RE: Kodiak Mining Company, LLC
Coke Mine No. 1, P-3887, R-5

Revision No. 5 proposes to add additional area to the permit. Some of this area is in the watershed drains to Sediment Basin 015. This plan modifies the current plan to address the addition.

KODIAK MINING COMPANY, LLC
COKE MINE #1, P-3887, R-5
SEDIMENT BASIN 015 MODIFICATION

**SPILLWAY CHANNEL SPECIFICATIONS
SEDIMENT BASIN 015**

PLAN VIEW DRAWING
SCALE: 1" = 100'

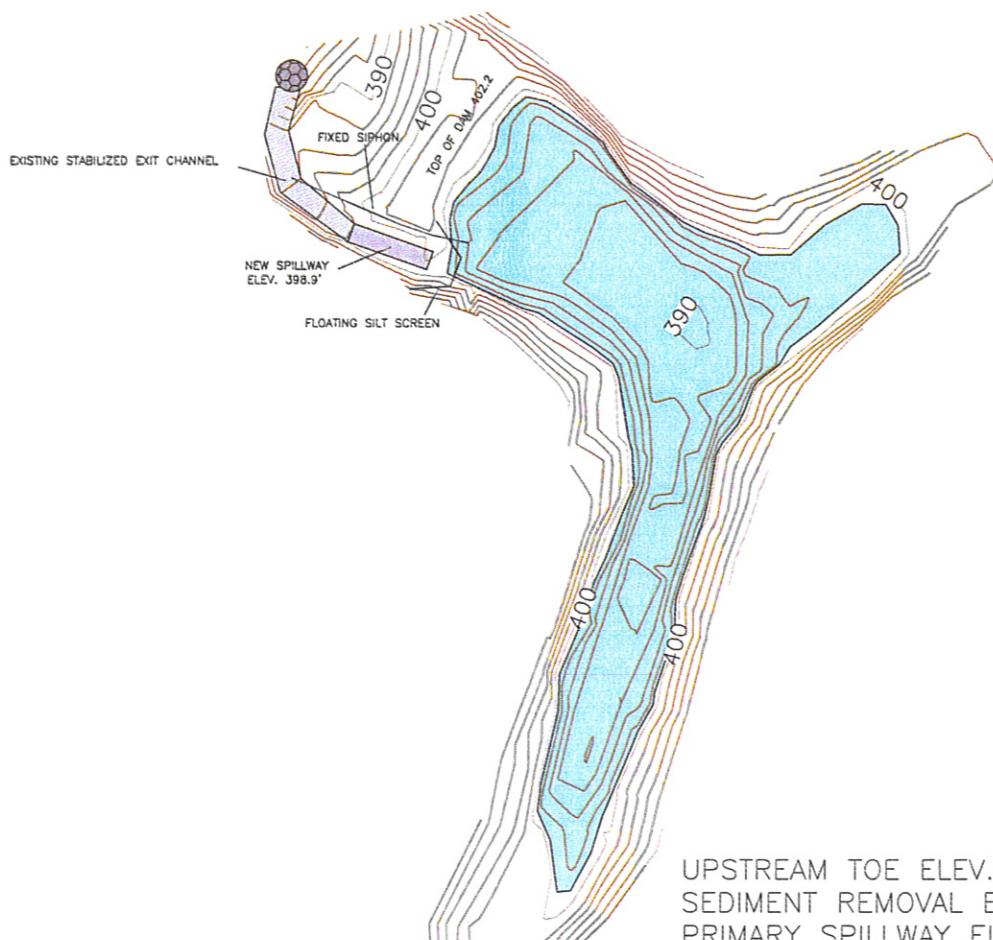
1. Narrow the existing spillway to 10 feet wide.
2. Add a fixed siphon tube.
3. Raise the top of dam elevation to 402.2 (only in small areas).

UPSTREAM TOE ELEV.: 379.9'
 SEDIMENT REMOVAL ELEV.: 396.09'
 PRIMARY SPILLWAY ELEV.: 398.9'
 FIXED SIPHON: 4" PLASTIC PIPE
 SIPHON INLET ELEV. 396.7'
 SIPHON CREST ELEV. 398'
 **MAXIMUM WATER ELEV.: 401.11'
 TOP OF DAM ELEV.: 402.2'

SPILLWAY: 10' WIDE TRAPEZOIDAL,
CONCRETE LINED

**SPILLWAY PROFILE
SCALE: 1" = 10' H&V**

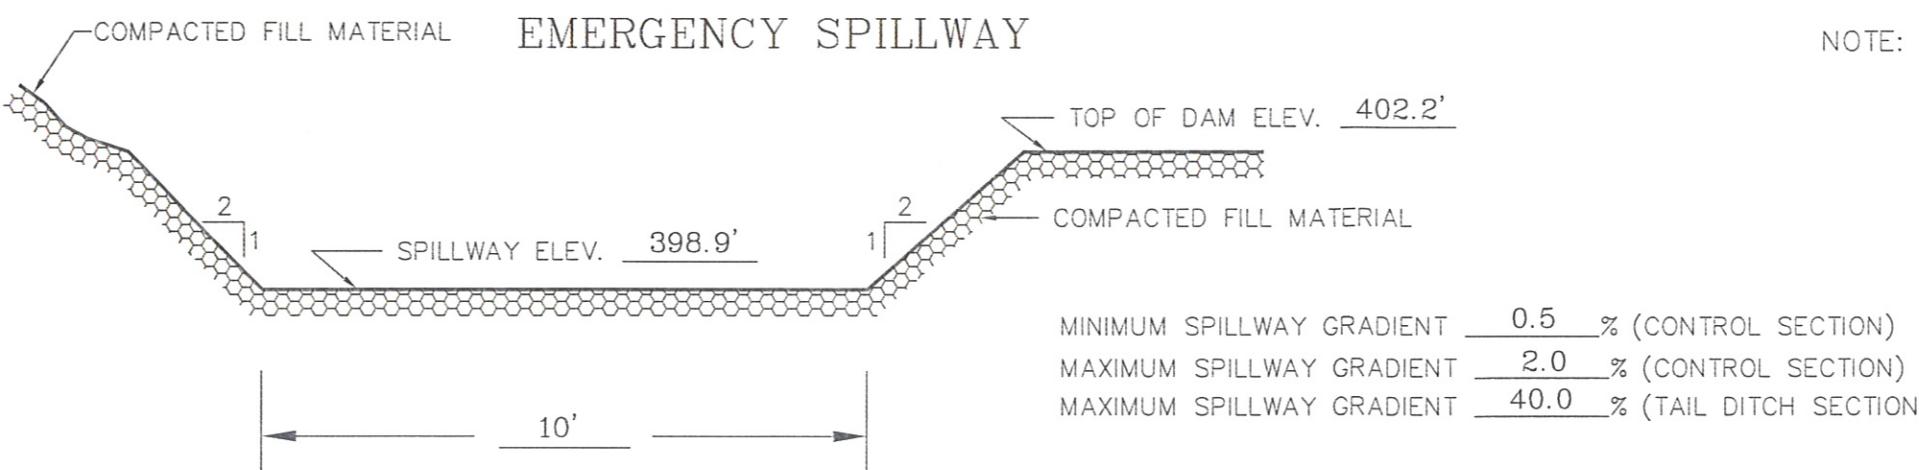
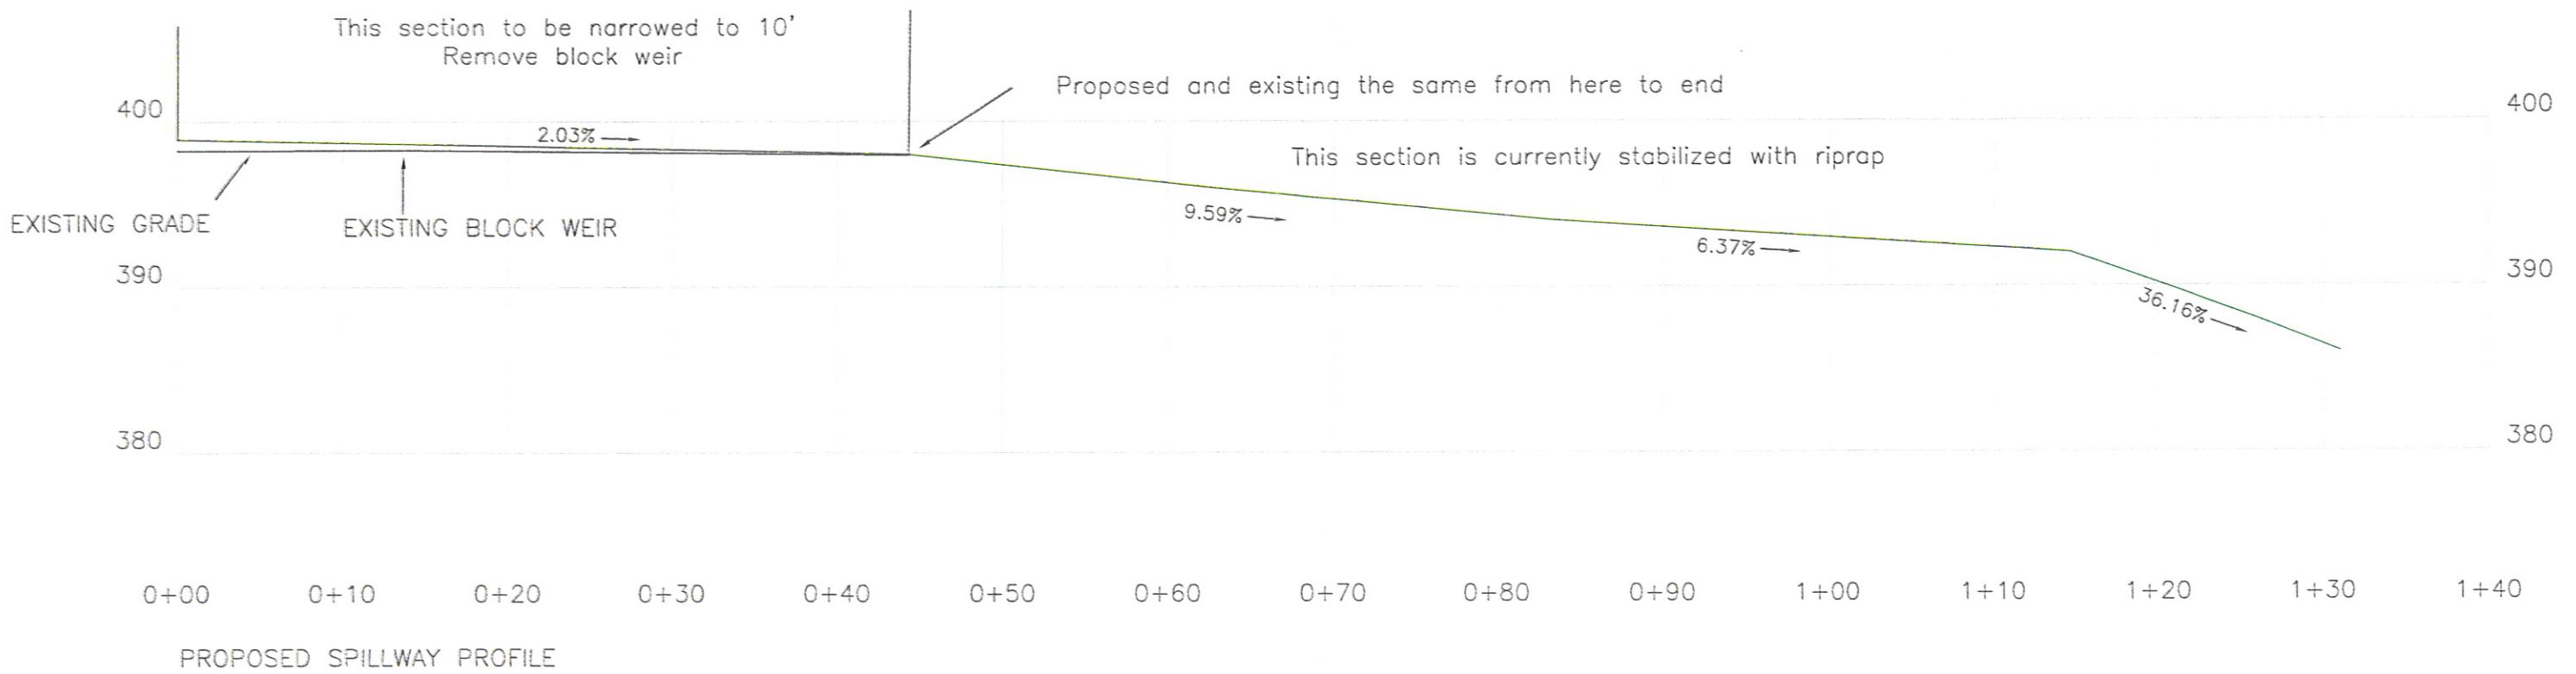
The existing spillway has a block weir inside a concrete lined trapezoidal channel. The tail ditch section from the block weir is concrete for a short distance and then is lined with large riprap. The tail ditch varies in width from 12 to 14 feet. The entire spillway is stable and shows not major erosion. A profile of the existing and proposed changes is attached.

This plan proposes to change the spillway in the control section to make a 10 feet wide trapezoidal channel lined with four inches of concrete. It will tie to the existing tail ditch which is in tack. Calculations in this section are based on a continuous 10 feet control and tail ditch section to eliminate various depths along the profile. During the modifications riprap and concrete will be extended as necessary to accommodate these calculations.

The entire control section of the emergency spillway will be lined with a minimum of 4 inches of reinforced concrete. All concrete will be reinforced with 10 gauge, 6" x 6" welded wire mesh. Fibermesh may be added to the concrete for additional strength, however, the addition of fibermesh shall not be used in place of the required 6" x 6" welded wire.

The gradient of the control section of the emergency spillway will not exceed 2 percent. The gradient of the tail ditch section of the emergency spillway will not exceed thirty six (36%) percent.

The concrete liner of the control section of the emergency spillway will be a minimum of 3.2 feet as measured vertically, allowing 2.2 feet for the maximum anticipated flow and 1.0 feet of dry freeboard. The riprap liner of the tail ditch section of the emergency spillway will be a minimum as shown on the attached SEDCAD4 flow calculations attached. All calculations show Class 2 riprap is sufficient. In most areas the existing conditions will meet this design. Riprap will be added in any areas not meeting the design. The original design shows the 36% slope area to have Class 5 stone. There is very large stone in this section. As stated above, there is no signs of erosion in the existing spillway, therefore only minor maintenance as necessary will be performed.
